**DENDROBIUM MINE - PLAN FOR THE FUTURE:  
COAL FOR STEELMAKING**

**AMENDMENT REPORT  
AUGUST 2020**

**Figure: 2**  
 Project General Arrangement-  
 Underground Mining Areas  
 Avon Reservoir FSL updated to 320.18m  
 Version 2 14 July 2020

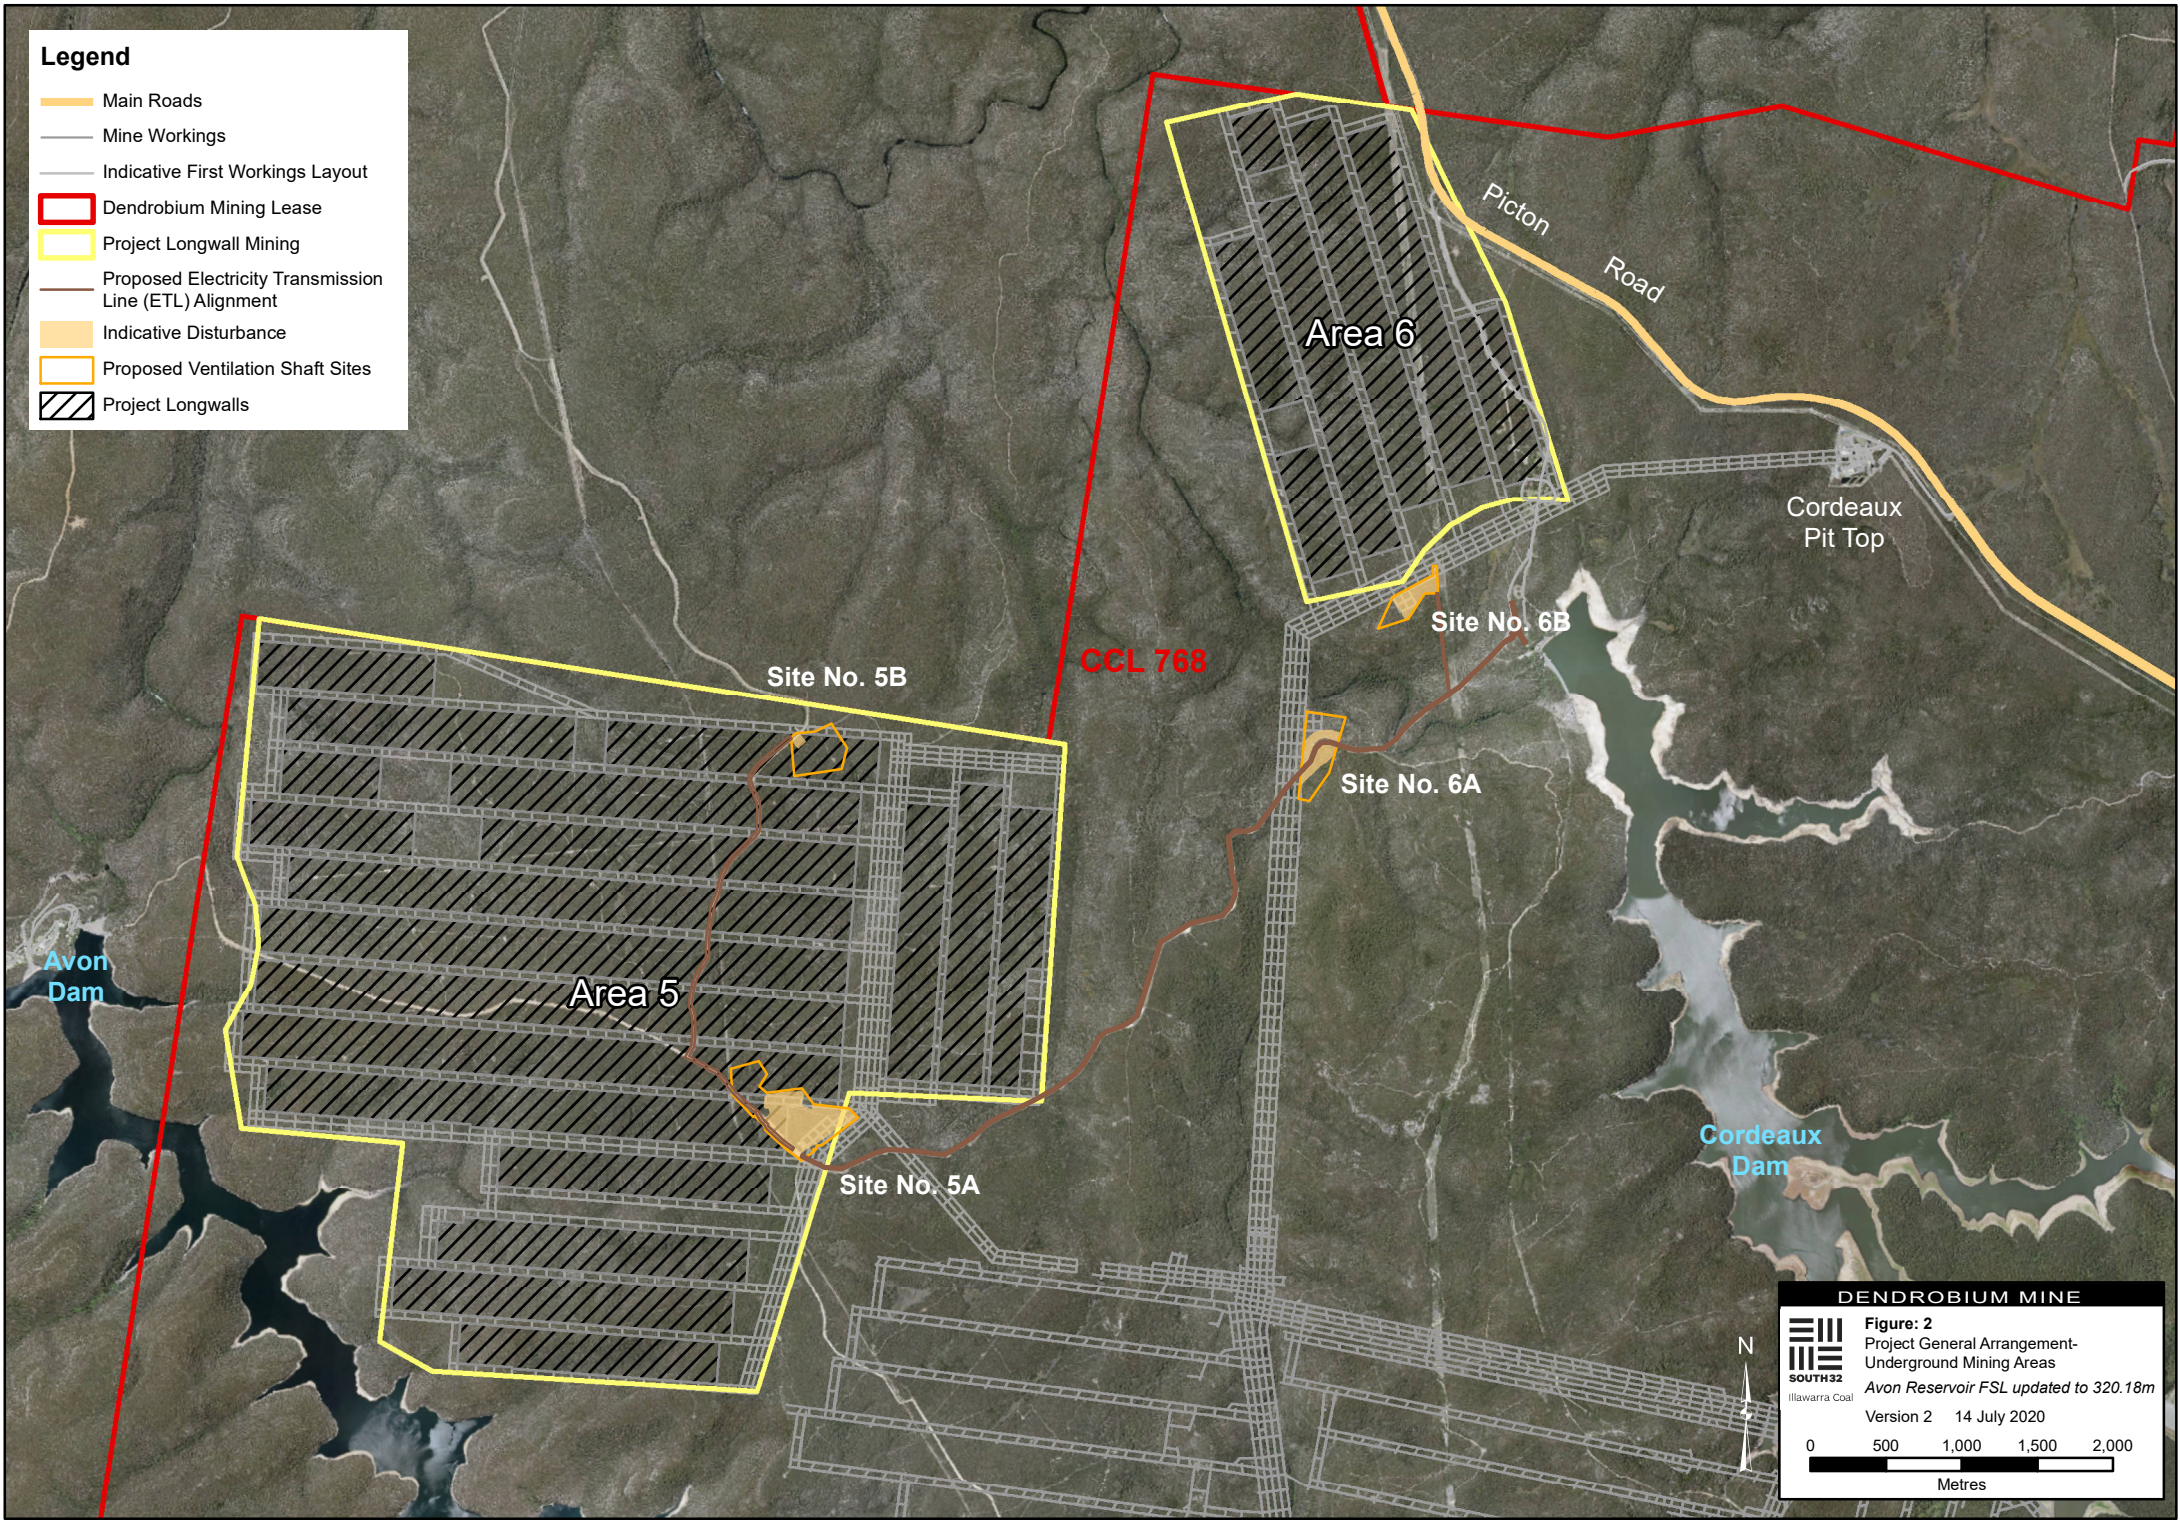
The revised native vegetation disturbance for ancillary infrastructure is summarised in Table 1 and is shown on Figure 2.

South32 has obtained more detailed surface contour data which has resulted in a refinement to the FSL mapping for the Avon Dam. As a result, South32 has revised the proposed longwall layout for the Project Area 5 to ensure the 300 m setback distance from the Avon Dam FSL is achieved.

The revised Project longwall layout, which shows the revised extent of the Area 5 longwalls, is shown on Figure 2.

**DENDROBIUM MINE**  
Setbacks Adopted in the Amendment  
Report Mine Plan from Named  
Watercourses and Key Stream Features

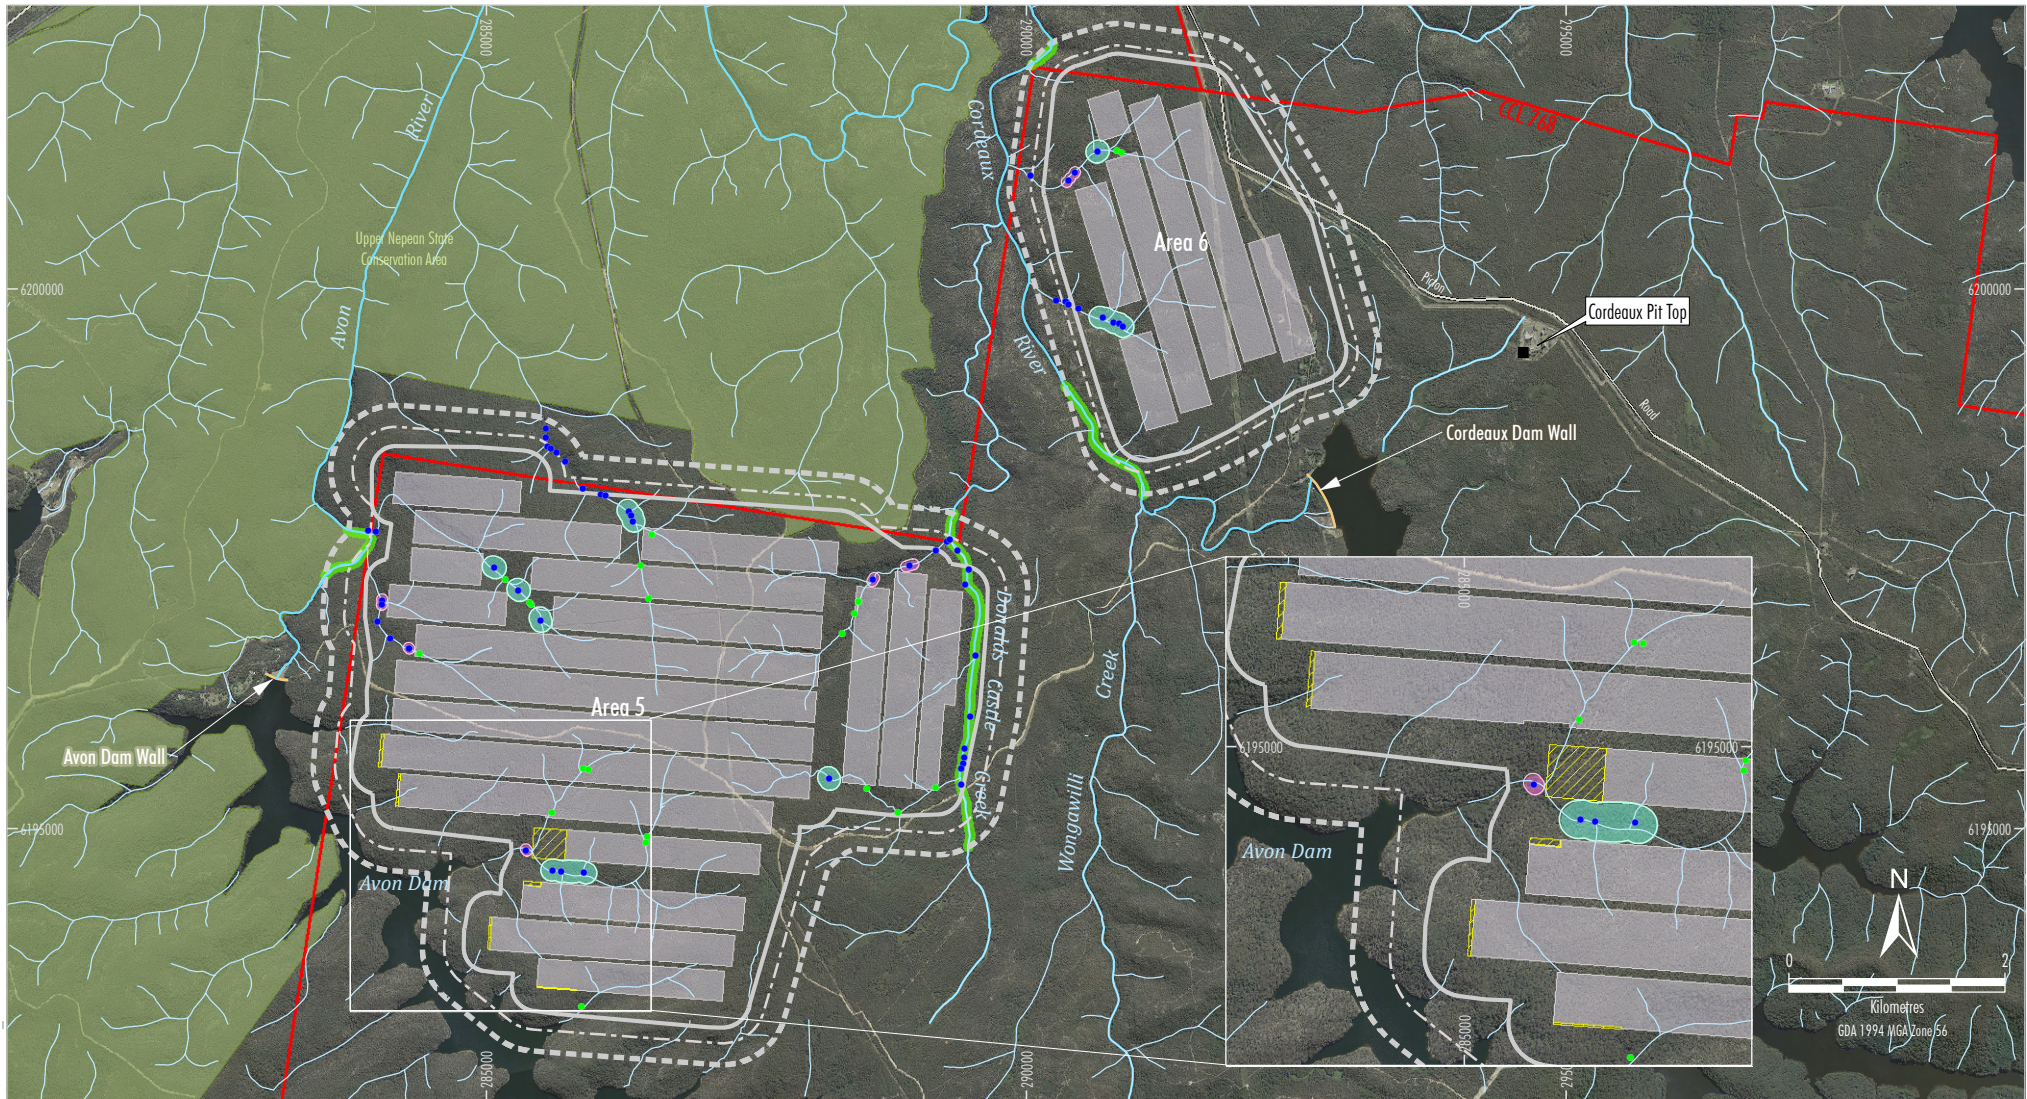
As a result of the revised longwall layout to achieve South32's mine design criteria of a setback from the Project longwalls by a minimum of 300 m from the FSL of the Avon Dam, there would be a minor reduction in the extent of the Area 5 longwalls. The main reduction would be the shortening of the western end of Longwall 516 by approximately 303 m (Figure 3).

As a result of the reduced longwall extents, the revised Project would avoid the direct undermining of additional drainage lines and stream features that would have otherwise been located above the Project longwalls, including (Figure 3):

**Disturbance Areas (West)**  
**Dendrobium Mine - Plan for the Future:**  
**Coal for Steelmaking - Biodiversity Assessment**

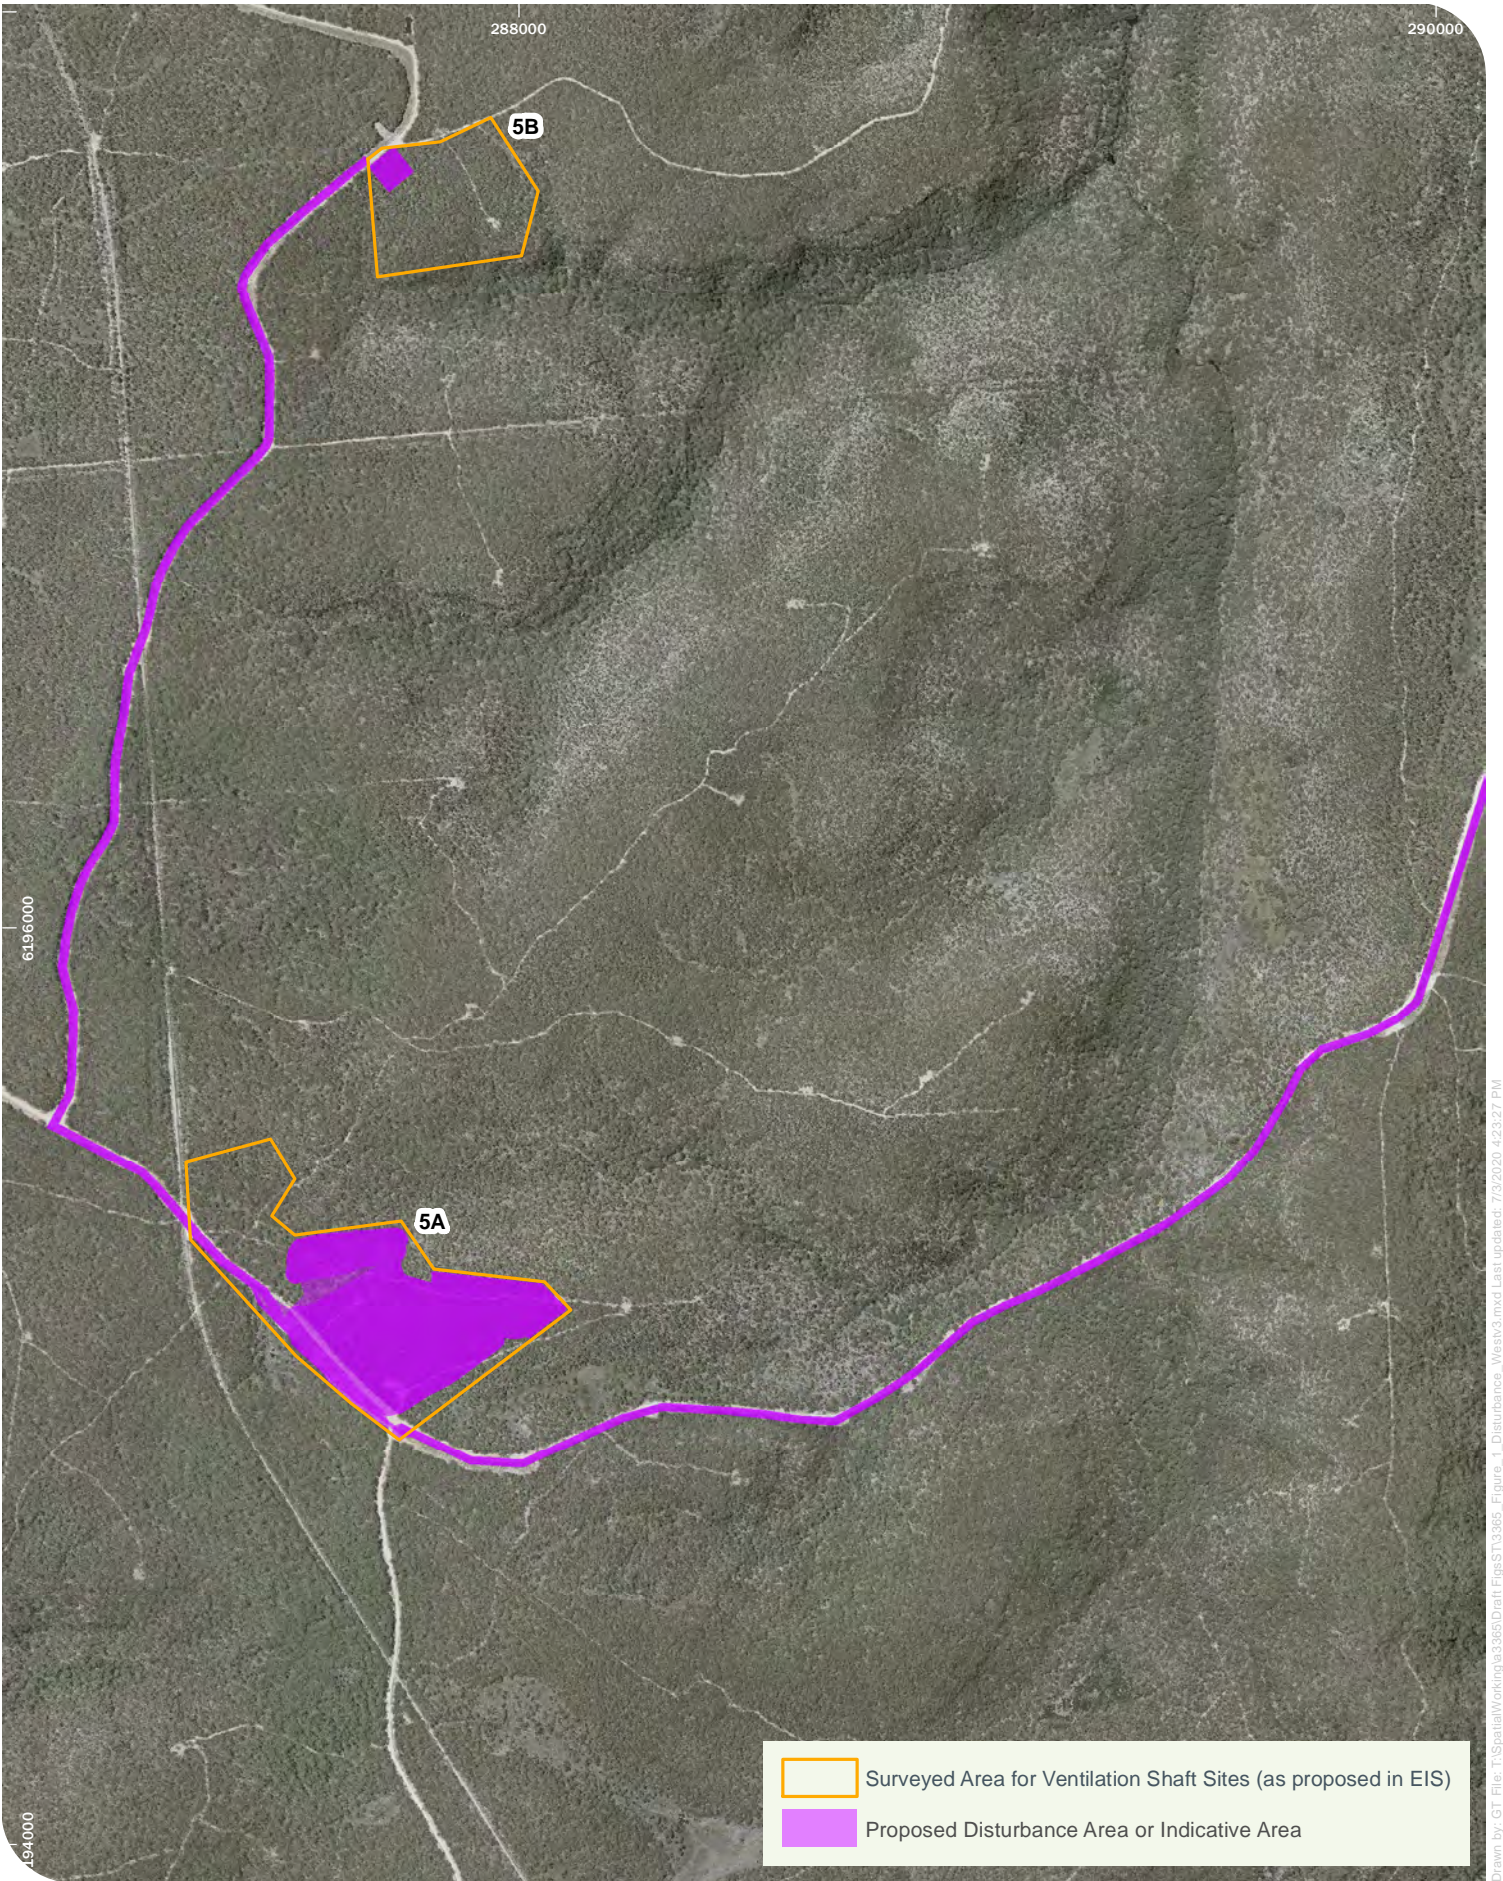
Since that time, the concept design for Ventilation Shaft Site 5A has been further developed by South32 (Figure 1). Ventilation Shaft Site 5A is scheduled for construction to commence in 2021 and the proposed disturbance area has been increased to approximately 15 ha in order to optimise the site to efficiently and effectively service the Area 5 mining activities. The main design features that require the additional footprint on this site include:

Since the BARBOS was submitted, a refined footprint for Ventilation Shaft Site 5A was provided to Niche (as shown in Figure 1 and Figure 3) which also incorporates service borehole sites. The amount of required clearing within the remaining ventilation shaft sites was also revised, however the exact location of clearing within these sites has yet to be determined. For the purposes of conservatively calculating clearing impacts in vent shaft sites other than Ventilation Shaft Site 5A, all clearing is assumed to be in the good condition vegetation zone. Therefore any change to the location of disturbance within the surveyed areas for the other ventilation shaft sites would not result in a change in the associated offset requirement.
